| LINE  | QUANTITY | UOP | CAT. NO. | ITEM NUMBER | UNIT PRICE | AMOUNT |
|---|----------|-----|----------|-------------|------------|--------|
| ***** ADDENDUM NO. 6 *****  |          |     |          |             |            |        |

Addendum No. 6  
Berkeley Springs Bath House  
DNR 209090

**DEPT. of Natural Resources**  
**Additions and Alterations to**  
**Berkeley Springs Bath House**

**DNR-209090**

| REV. BY:<br>MEI  | DWG. DESCRIPTION:<br>ALTERNATE NO. 1<br>ADDITIONAL NOTES | DWG. NO:<br>AD-008 1 OF 1 |

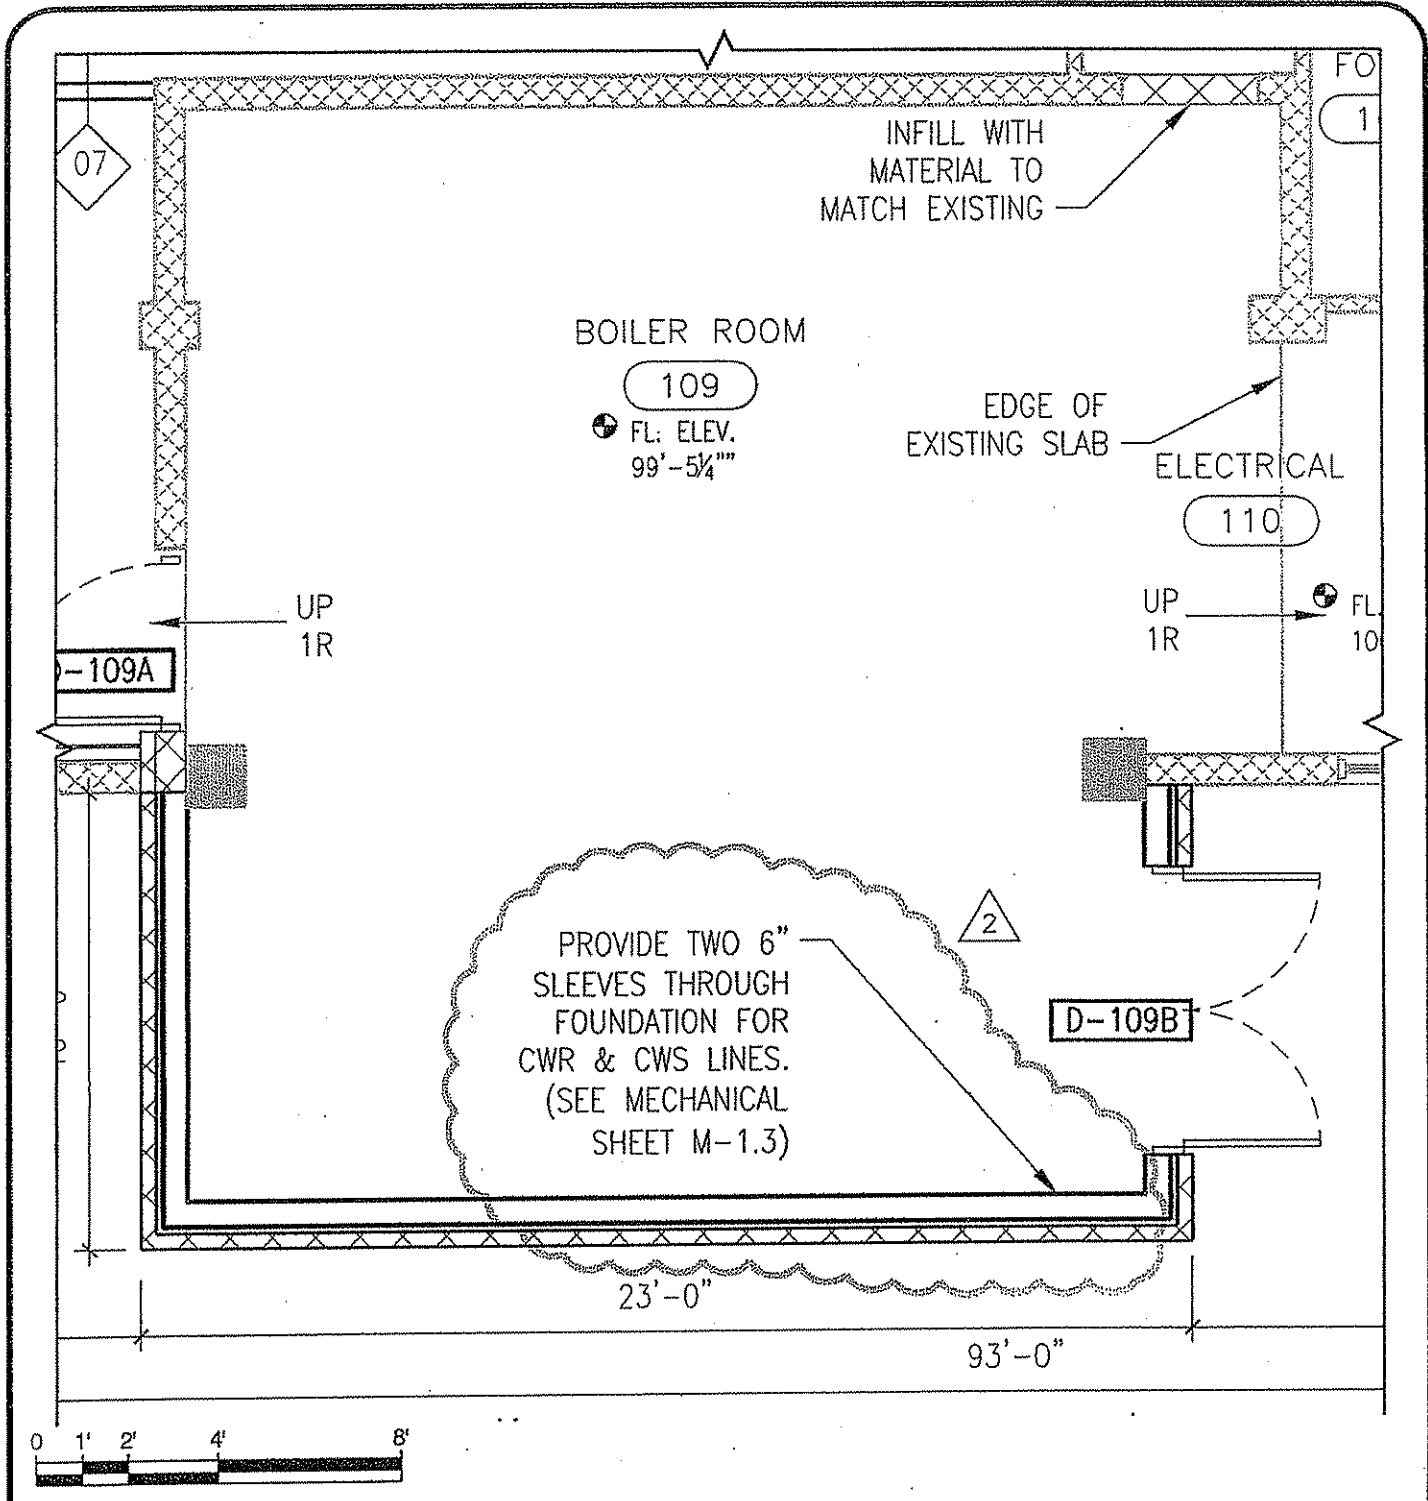
- 3.02 Sheet A-1.A- Alternate No.1  
ADD: Notes I, J, K as listed on AD-008 1 of 1 attached.
- 3.03 Sheet A-1.1- Floor plan  
ADD: location of 2 6" dia. Sleeves through foundation for Water lines, see clouded area of AD-009 1 of 1 attached.

| DATE:<br>03-02-2009  |  | SHEET REF:<br>A-4.6       |

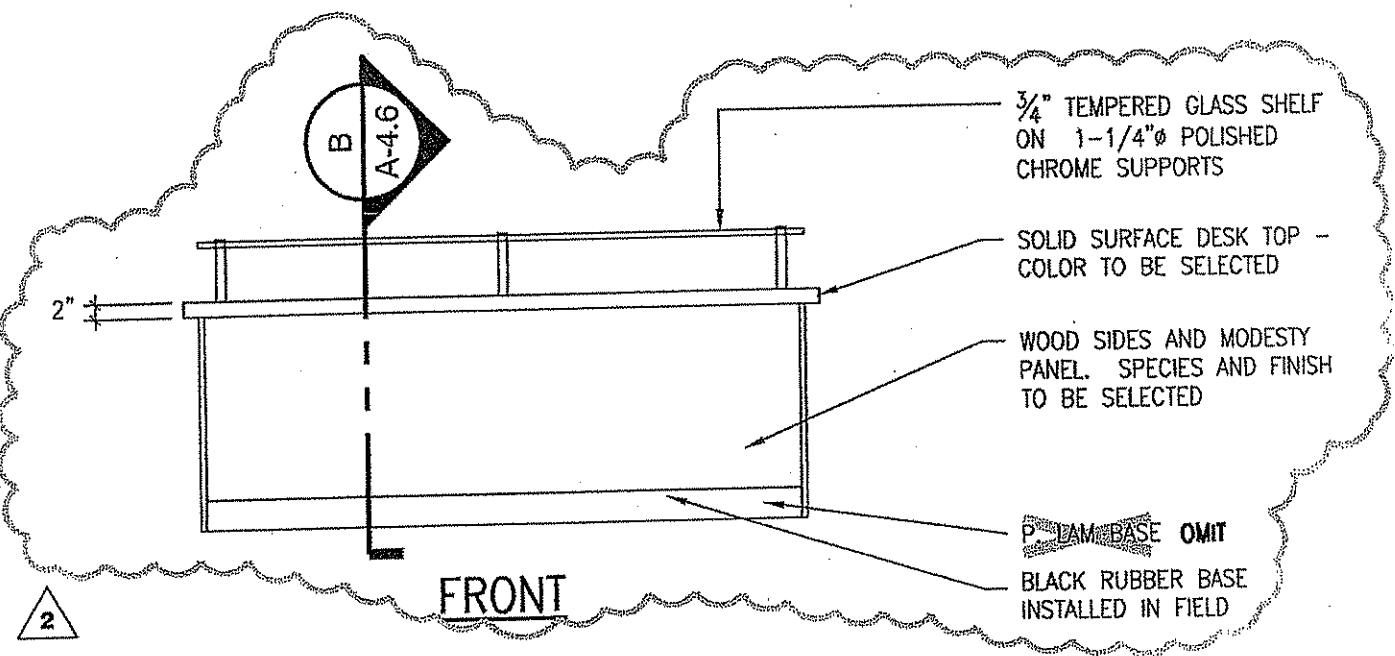
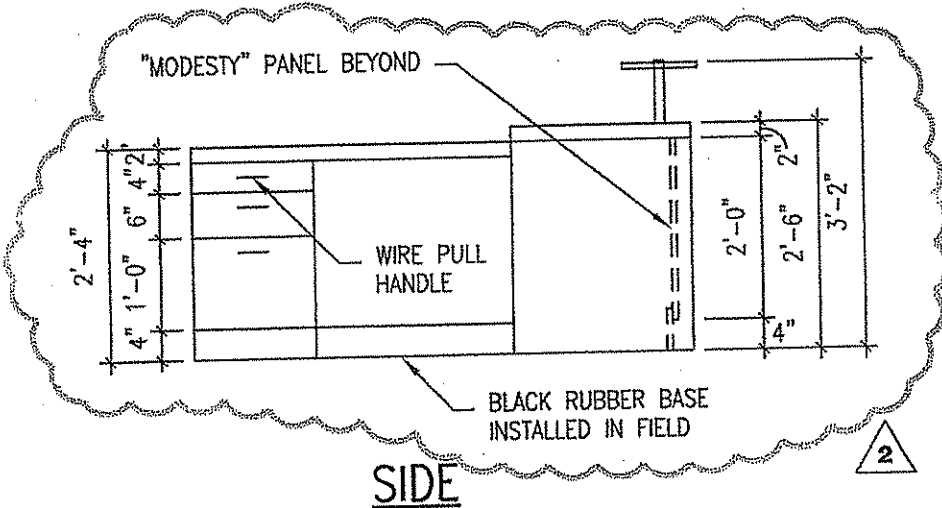
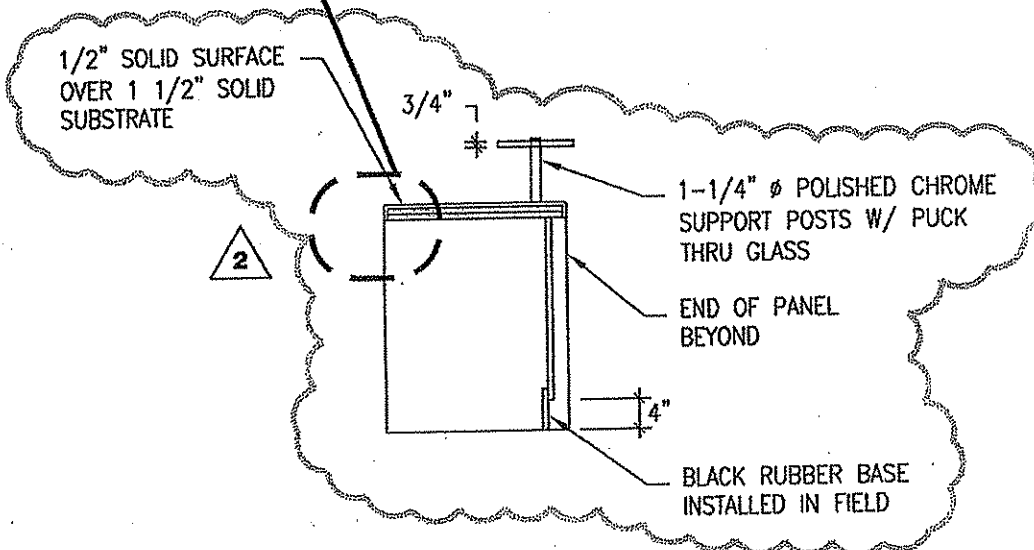
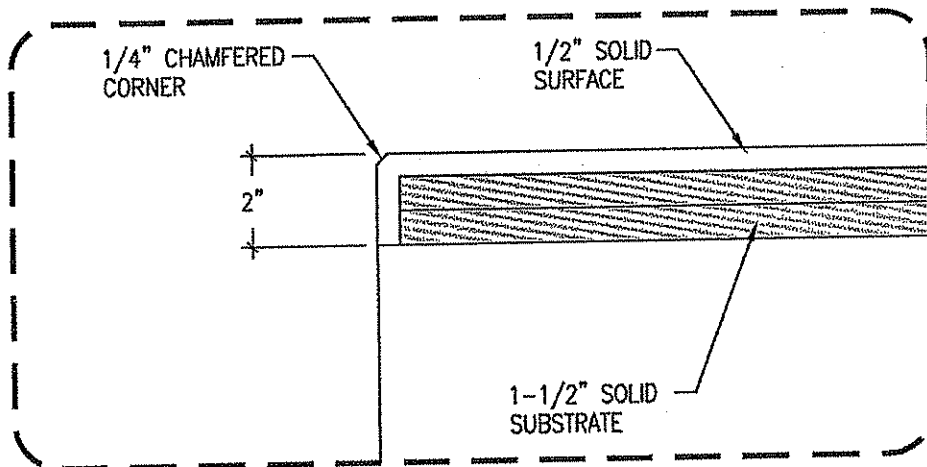
- 3.04 Sheet A-2.2- Front elevation façade.  
ADD: New 24" x 24" access to crawlspace with permanent screened louver, see AD-004 attached.
- 3.05 Sheet A-4.6- Enlarged Reception Desk Details  
CLARIFY: See AD-010 attached.

- 4.02 Q: On Drawing A-4.6 Enlarged Plan-New Reception Desk, show a glass inset panel with a pencil drawer below. Is this correct?  
A: No, leader is drawn incorrectly. Return and front top are solid surface material, glass top is only over shelf at front of desk. See AD-010 and Section 3.17 above.

- 4.03 Q: The base at the New Reception Desk is P. Lam. Is this correct?  
A: See AD-010 and Section 3.17 above. P. Lam has been omitted from desk.
- 4.04 Q: Is there any additional insulation in the attic area? (except the area shown for the new mechanical units).  
A: No.
